Technical Service Bulletin

Subject: HARD SHIFTING/SHIFT LEVER VIBRATION	Bulletin No.: 05-002/17
	Last Issued: 07/06/2017

Location of Transmission Related Parts

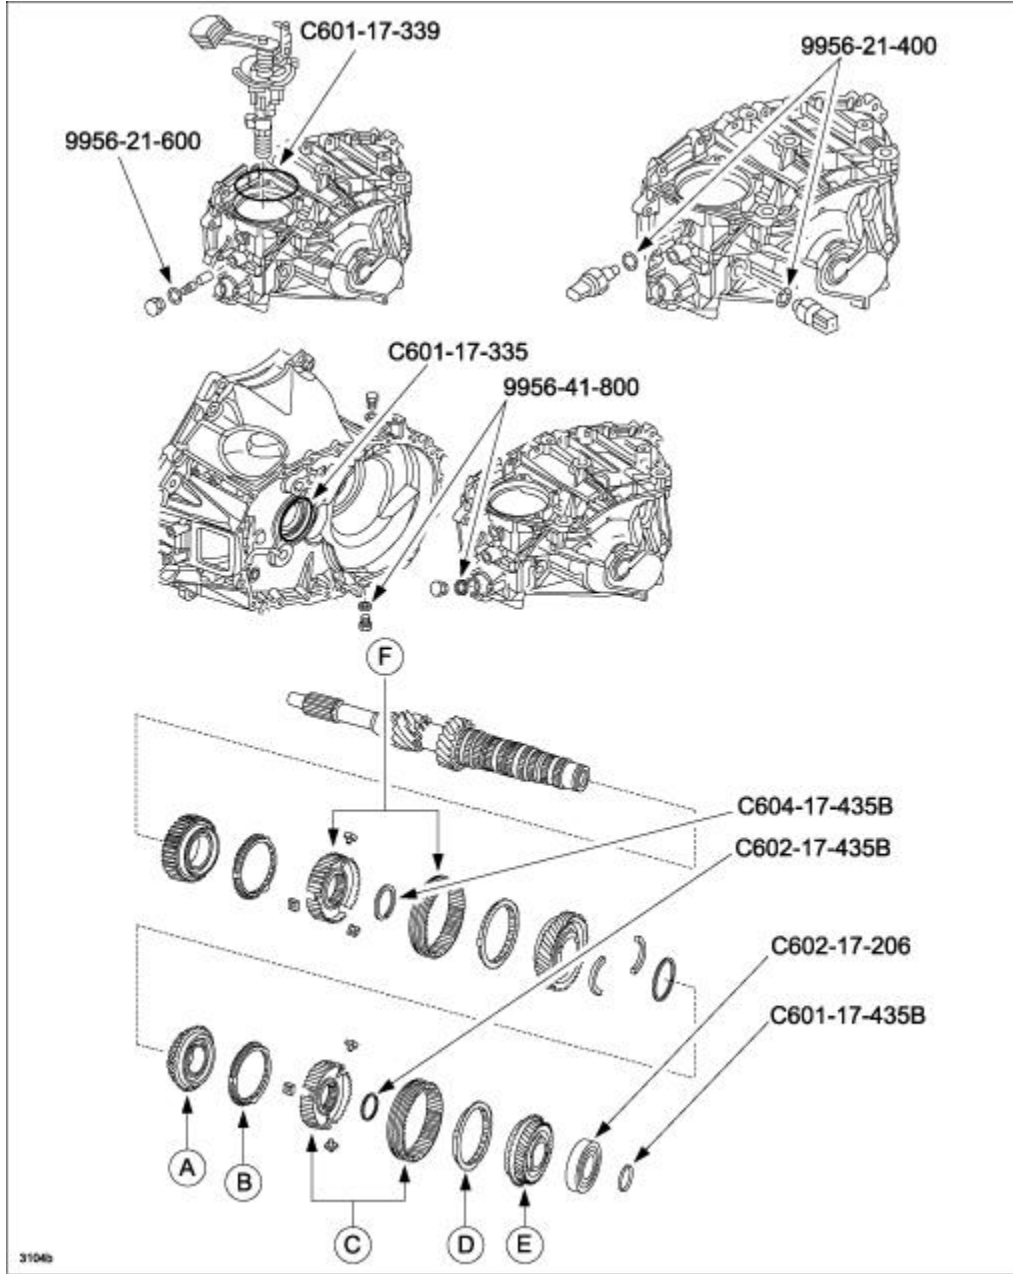
Modification	Subject Part	Changes	Subject Concern
A	3-4 Clutch Hub	Surface Treatment	Jumping out of gear
B	3-4 Clutch Hub 5-6 Clutch Hub	Shape	Hard shifting into 3rd, 4th, 5th and/or 6th gear
C	3rd and 4th Gears	Tolerance	Shift lever vibration
D	3rd and 4th Gears 3rd and 4th Synchronizer Rings	Shape	Hard shifting into 3rd and/or 4th gear (additional improvement)

A: 3rd Gear

B: 3rd Synchronizer Ring

C: 3/4 Clutch Hub Assembly

D: 4th Synchronizer Ring

E: 4th Gear

F: 5/6 Clutch Hub Assembly
